Administrative Approval Action

AA# 3857 / S-51-16, Point Subdivision Transaction# 483263

- **LOCATION:** This site is located on the northeast corner of the intersection of South Person Street and Bledsoe Avenue at 915 S. Person Street.
- **REQUEST:** Subdivision of a 0.15-acre tract zoned R-10 and within an NCOD Overlay (Southpark District), into two residential parcels.

Design Adjustment Staff Response

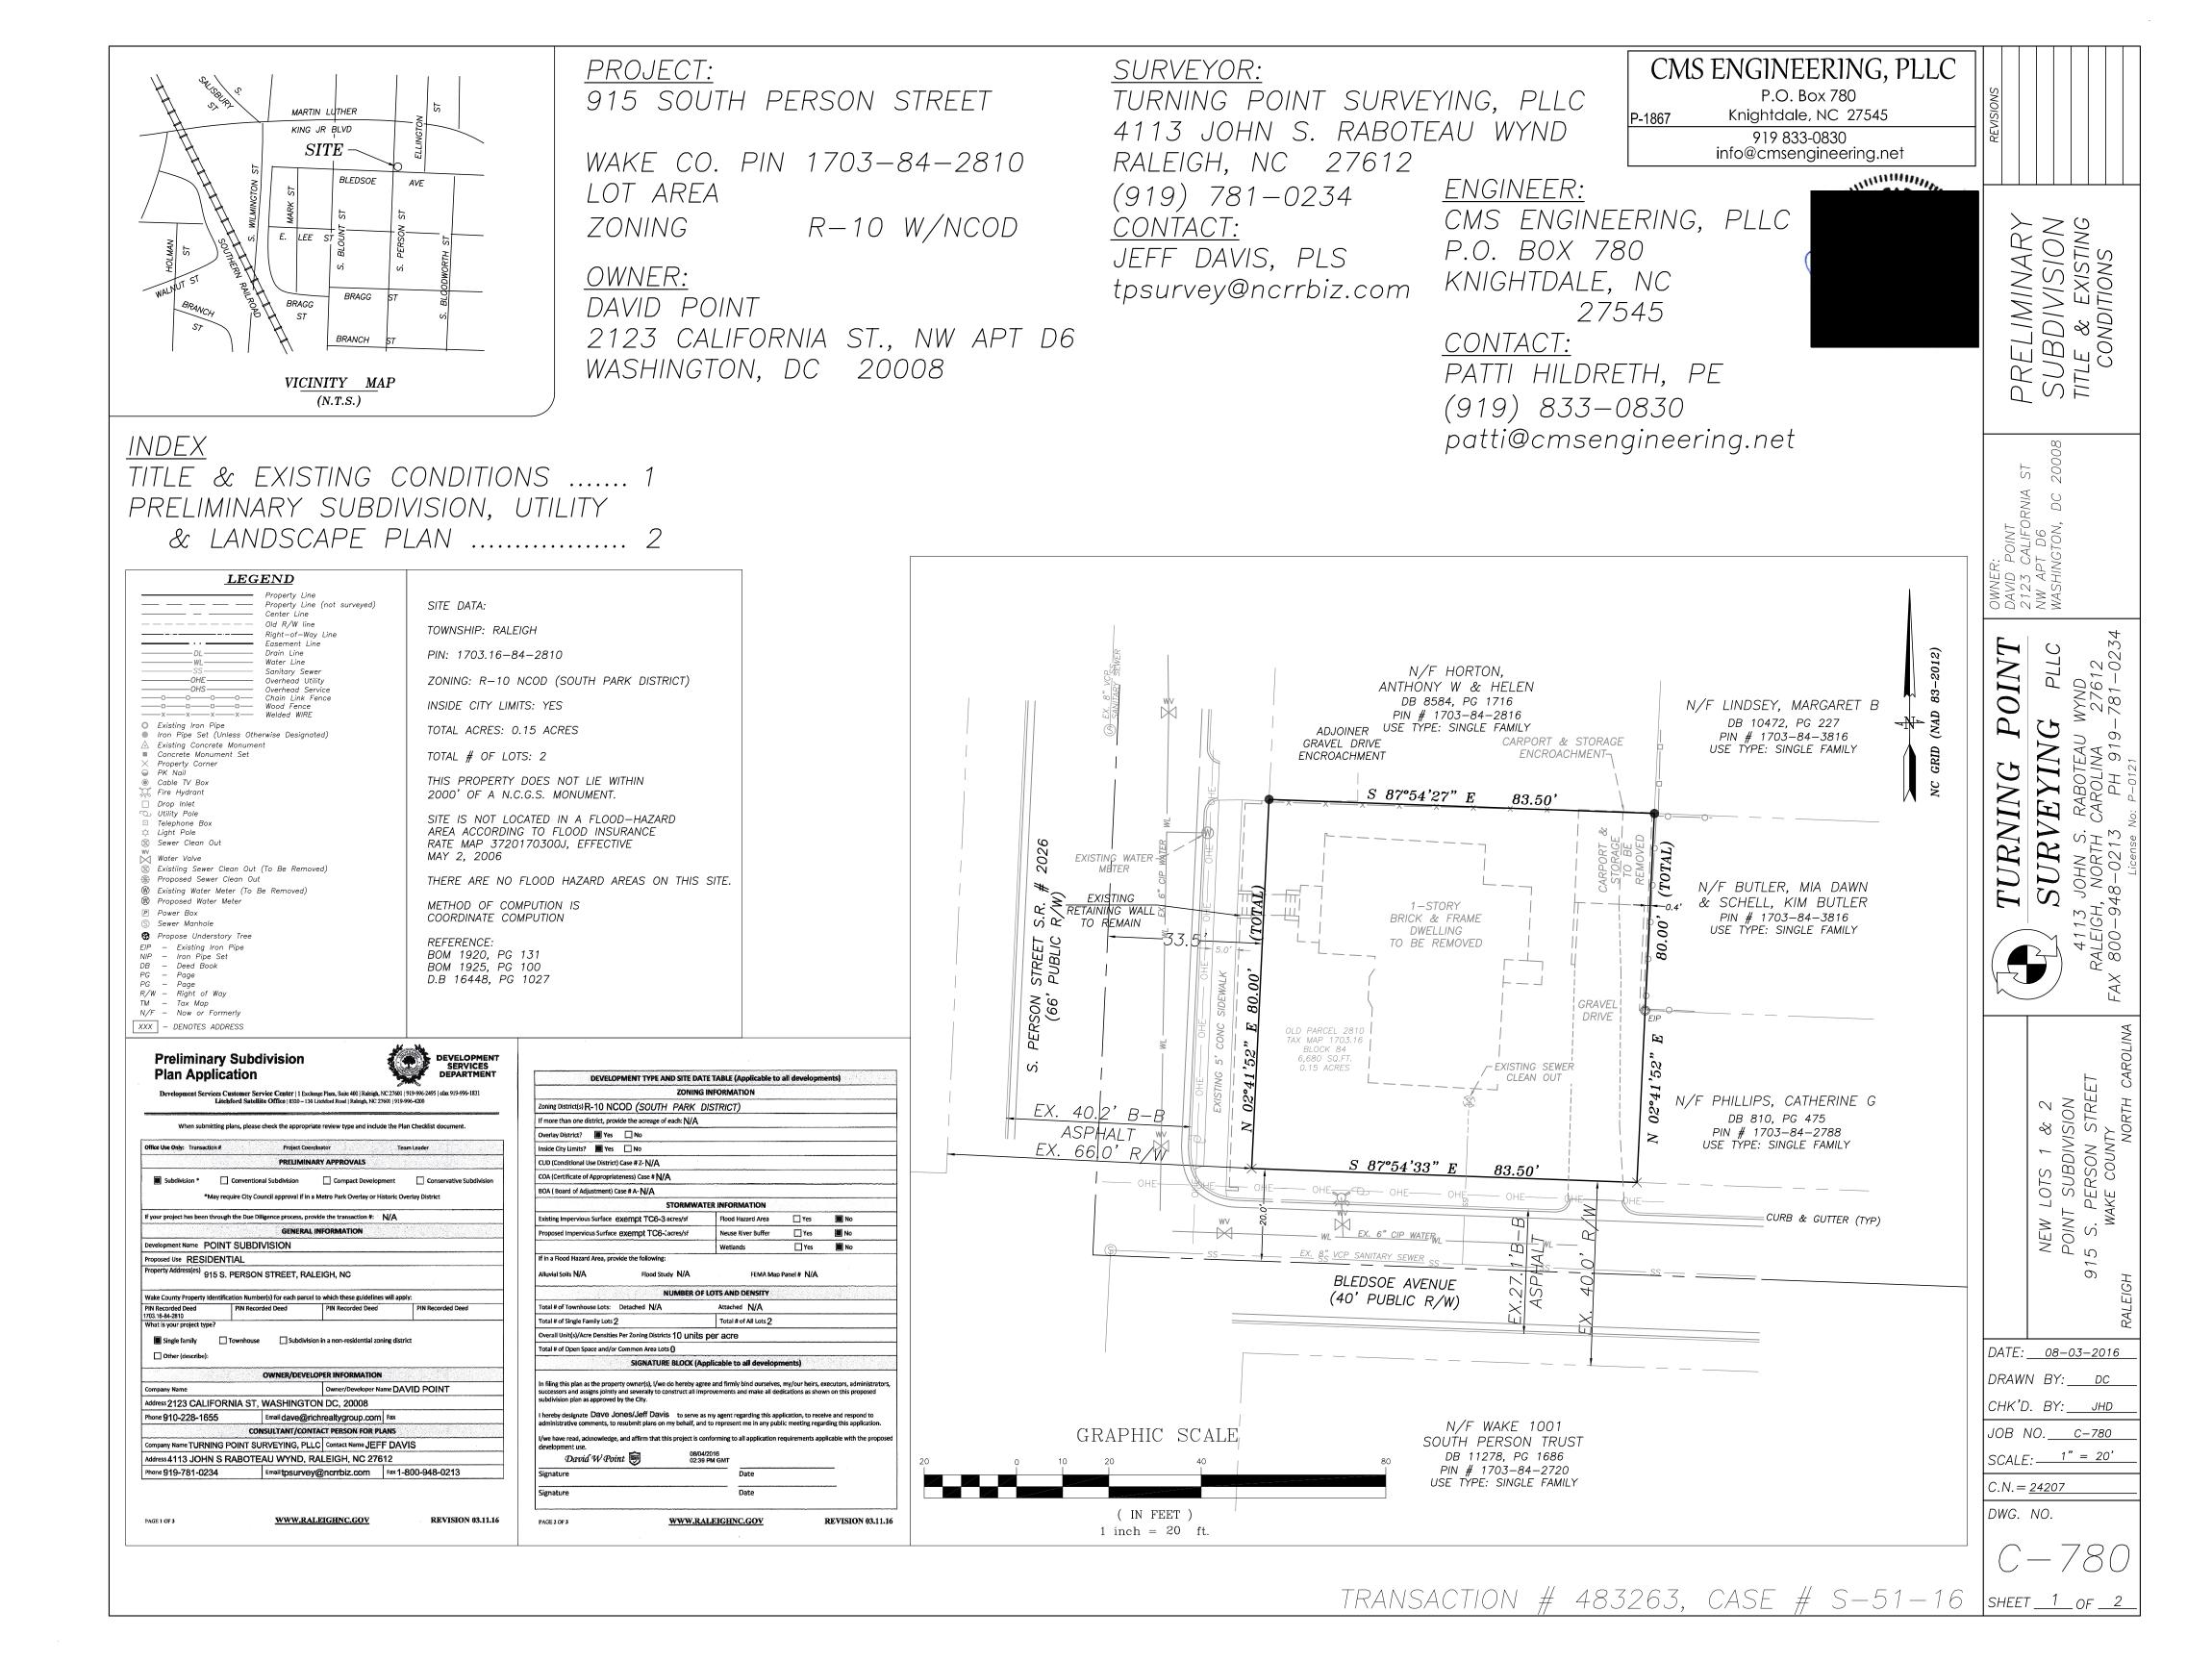
This design adjustment is to request that the existing 3.5' grass strip and 5' sidewalk on S. Person Street is to remain as an alternate streetscape from the classification per the Street Plan Map which requires an Avenue, 4-lane facility with parallel parking. RSDM 4.4.1. A fee-in-lieu will be required for 1' sidewalk width to meet the UDO 6' sidewalk width requirement and dedication of slope easement to allow the sidewalk to be constructed with sufficient easement width along S. Person Street.

- 2. The required ½-55' right of way for Bledsoe Avenue shall be dedicated to the City of Raleigh and shown on the map approved for recordation.
- 3. A 5' general utility easement and associated deed of easement shall be approved by the City and the location of the easement shall be shown on the map approved for recordation. The deed of easement shall be recorded at Wake County Register of Deeds within one (1) day of recordation of the recorded plat. A recorded copy of these documents must be provided to the Development Services Department within 14 days from authorization of lot recordation. If a recorded copy of the documents is not provided within this 14-day period, further recordings and building permit issuance may be withheld.

- 4. In accordance with Part 10A Section 8.1.10, a fee-in-lieu for 1' sidewalk width on S. Person Street frontage is paid to the City of Raleigh.
- 5. A joint driveway/cross access agreement for the proposed New Lot 1 and New Lot 2, shall be approved by the Development Services Department for recording in the Wake County Registry, and a copy of the recorded offer of cross access easement shall be returned to the Development Services Department within 1 day of lot recordation. A recorded copy of these documents shall be provided to the Development Services Department within 14 days from authorization of lot recording. If a recorded copy of the documents is not provided within this 14-day period, further recordings and building permit issuance may be withheld.
